**Subject** ▶ Change of Ball Bearing and removal of Ring 19

**For Models** ▶ 4322 4323 4322M 4323M

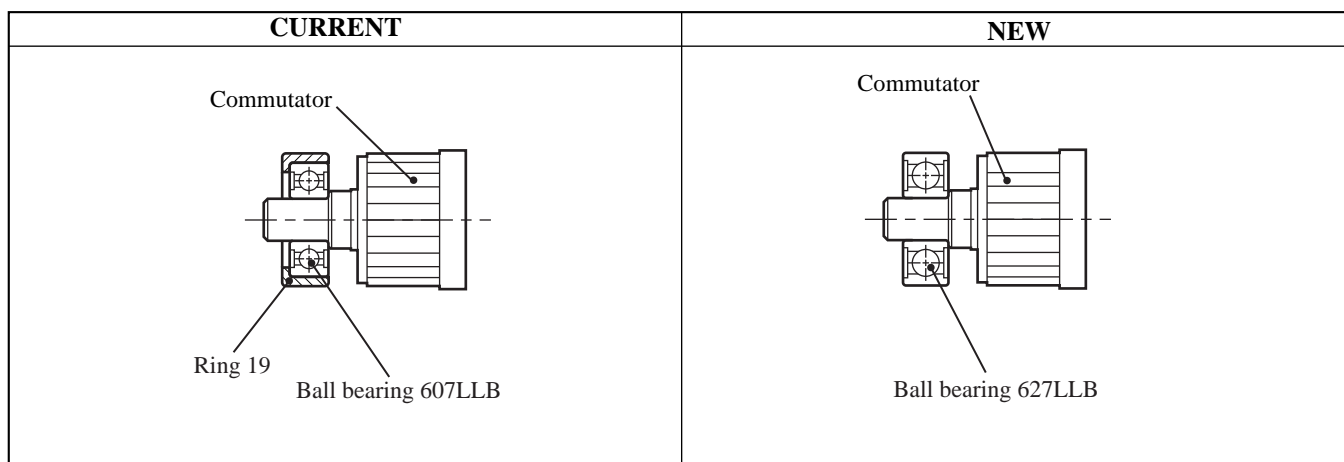
**Description** ▶ As illustrated below, Ball Bearing has been changed and Ring 19 has been removed.

Part Number of Armature Ass'y remains the same. Please remove Ring 19 when you use New Armature Ass'y.

Item No.	Curret part	Q'ty	New part	Q'ty	I/C	Note
032	Ball Bearing 607LLB 211021-9	1	Ball Bearing 627LLB 210025-8	1	No	Interchangeable as a set ↑ ↓
033	Ring 19 257216-0	1
